Interactive comment on “Multi-fidelity Fluid-Structure Interaction Analysis of a Membrane Blade Concept in non-rotating, uniform flow condition” by M. Saeedi et al.

M. Saeedi et al.

Received and published: 13 July 2016

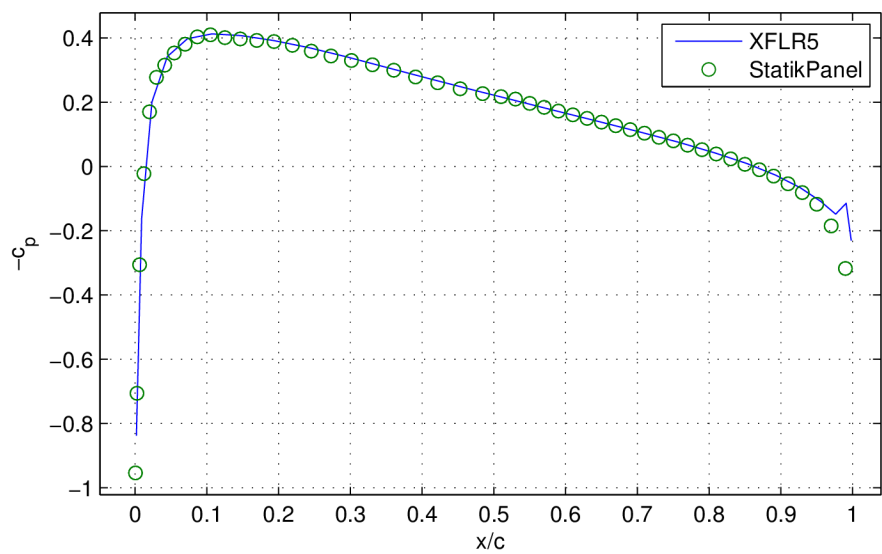
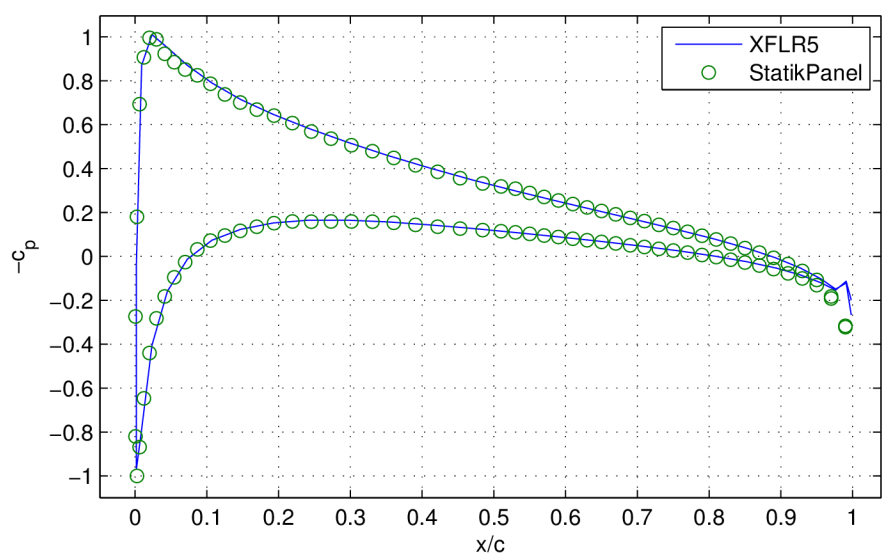
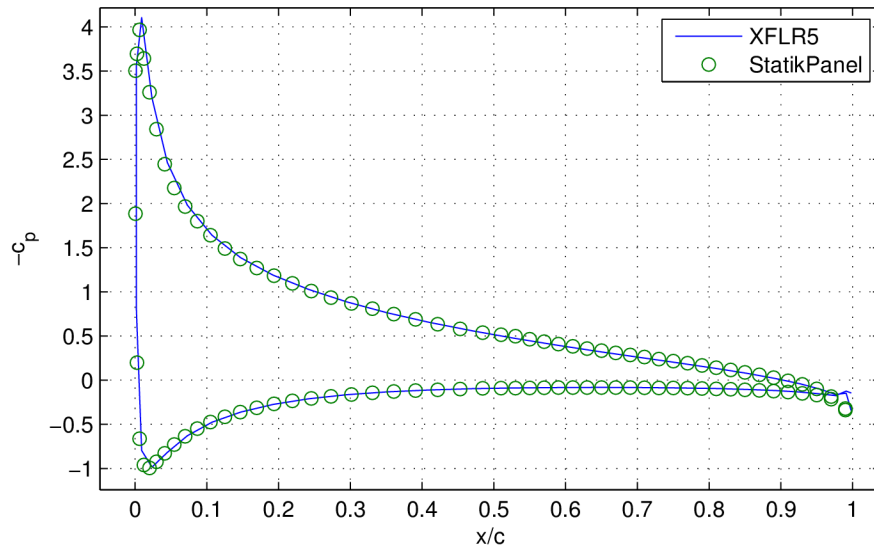
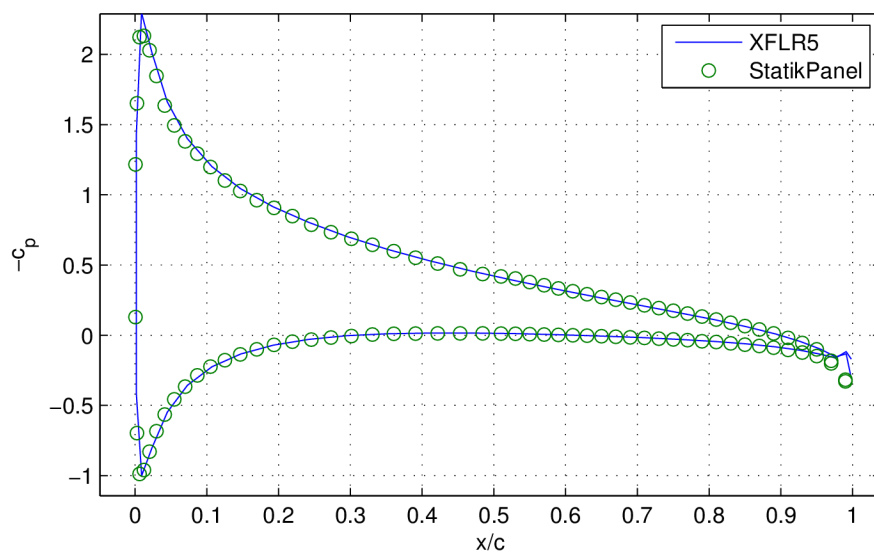
page 15, can you put a Fig of you grid around the blade surface near the tip and LE and TE? I would also like to know why you are using wall function?why not $y^+ = 1$? Do you know if the openfoam is validated for wind turbine analysis? can you reference to some works?

can you use eps format for your Figs?Fig 13 can be removed.

The mesh near the trailing edge and the leading edge of the blade is attached as a supplementary file. Using wall function rather than using a mesh with $y^+ = 1$ is for saving computational time. For the studied range of angles of attack the flow is mainly attached and good results are obtained using wall functions.

Apart from the mesh figure other figures are in .eps format. Detailed view of the mesh near the leading edge and the trailing edge region is added in .eps format.
